HL-LHC INTEGRATION MEETING

DSHX document

Finalization of DSHX length

Scope of the internal note is to define the nominal routing and final length.

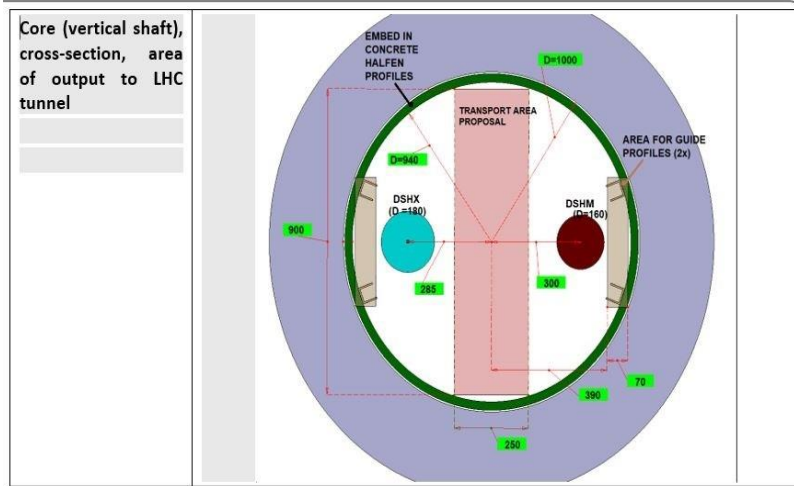
paolo fessia

UL/UR

Marcin:
**OK, corrected in
the document.**

Fig. 10 Layout of section 2 of DSHX routing scenario

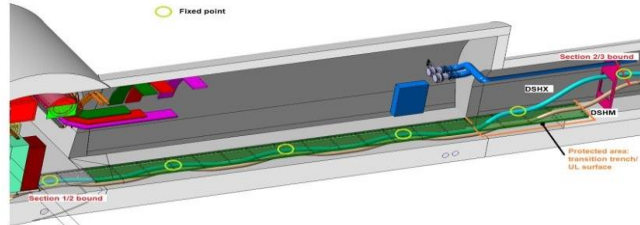
PF paolo fessia ...
To make clearer that is only the part external to trench
Mode I not provided to integration so not

PF paolo fessia
Again protection not provided yet to integration

The figure shows only the place for this system. No concept has been proposed at this moment.

The figure shows only the place for this protection system. No concept has been proposed at this moment.

Fig. 13 Layout of section 5 of DSHX routing scenario

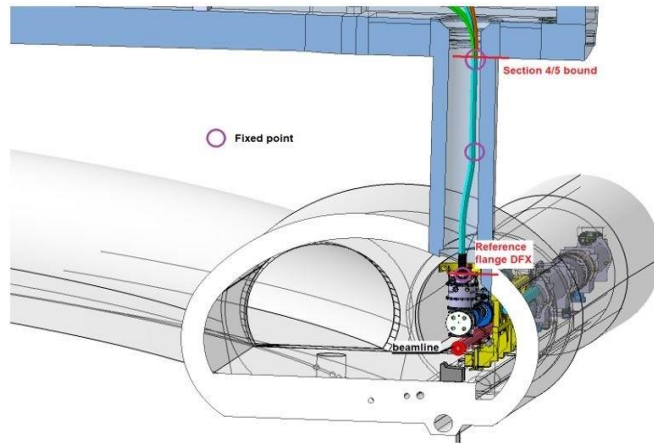
Both for the section 4 and 5: we do not have a proposal for the supporting tooling and the guide tooling in the core. We cannot approve that support and ensure that there is enough space
03 December 2021, 14:20

As the DFX interface point is slightly different it should be stated that the difference will be compensated along the core length or in the tolling at the entrance point in the core
03 December 2021, 14:24

Marcin:
Work on this supports is ongoing. That's right, we don't have a final concept in these areas.

Marcin:
OK, this information will be added.

Fig. 14 Diagram with description of nominal values.

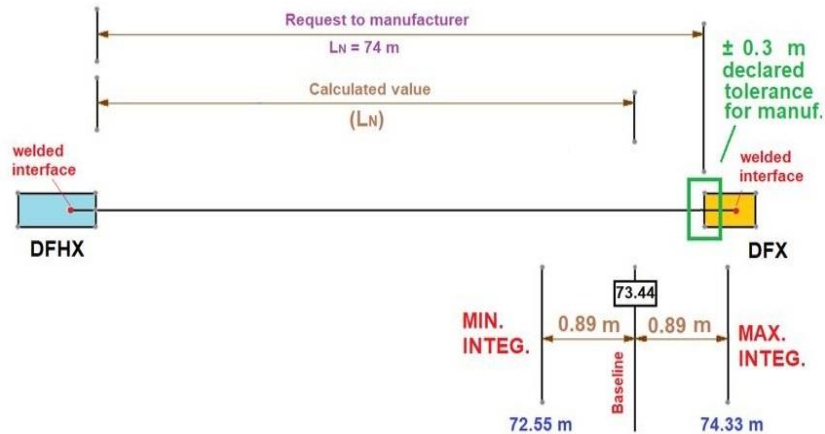
WP6A takes the responsibility to compensate for this extra 0.6 m of margin in the assigned installation volume

this point, was discussed and adopted by WP6A
